**Re: Airstream, Inc.
Defect and Non-Compliance Report**

SAFETY RECALL NOTICE

SERVICE BULLETIN

Bulletin Number: 141
Product Line: 2007 19' 75TH Anniversary
International Trailer
Subject: Furnace Vent
Attn.: Owner, General Mgr, Service Mgr

Figure 1.

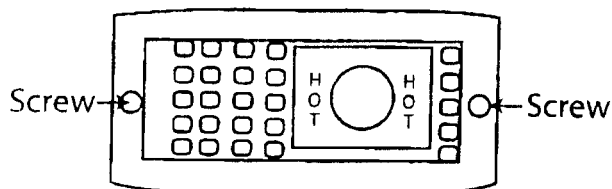
Problem: The wrong length vent kit is installed on the Hydroflame furnace. The vent tube and air box are not long enough to properly vent the furnace exhaust to the outside of the trailer.

1. Apply a layer of 2 inch paint quality masking tape around the furnace vent cap/tube assembly to prevent marring sidewall during removal.
2. Remove 2 screws holding vent cap/tube assembly to side wall (See Figure 1.)
3. Pull vent cap/tube assembly (Figure 2B) away from sidewall. Sealer around the top and sides of the cap may provide resistance to removal, however, steady gentle pressure will release the cover.
4. Pull Air Box (Figure 2A) out of the furnace assembly.

1. To install new air box (Figure 2A), apply sealant to back flanges on the air box (Figure 2A). Slide through outside wall cut out and into furnace air channel. **DO NOT FORCE OR BEND PARTS.**
2. Apply sealant to the top and sides of outer edge of vent cap. **DO NOT PLUG HOLES.** Slide assembly over furnace exhaust tube (Figure 2B), push into wall and secure with two screws.
3. Remove masking tape.
4. Reseal the cap (Figure 1) on the top and sides only with seam sealer. Leave bottom clear for drainage.

Figure 2.

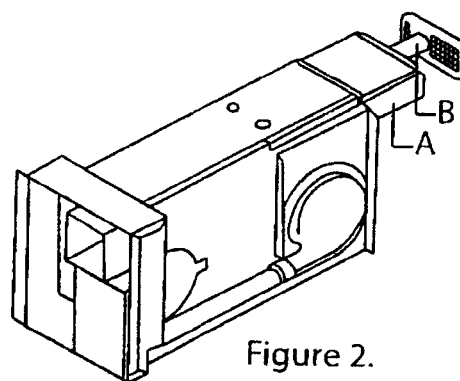
1 each: Hydroflame P/N 35947 vent air box (Figure 2A).

1 each: Hydroflame P/N 36446 vent cap/tube assembly (Figure 2B).

Solution: Replace Hydroflame vent kit # 36441 with Hydroflame vent kit # 36442.
